# PTO Linkage NSN Correction

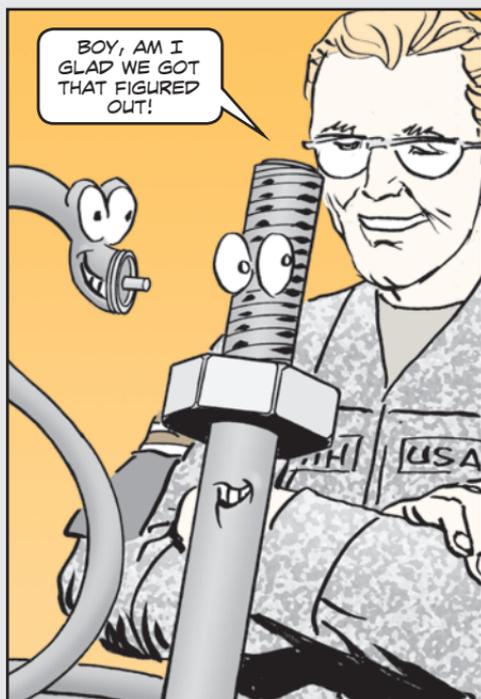
TM 9-2320-272-24P-2 gives the same NSN for Item 13 of Fig 525 and Item 16 of Fig 528. The problem is that these are actually two different items.

We later learned the correct NSNs: Item 13 of Fig 525 is NSN 2590-01-083-1155 (PN 11669342-1) and Item 16 of Fig 528 is NSN 2590-01-106-2060 (PN 11669463).
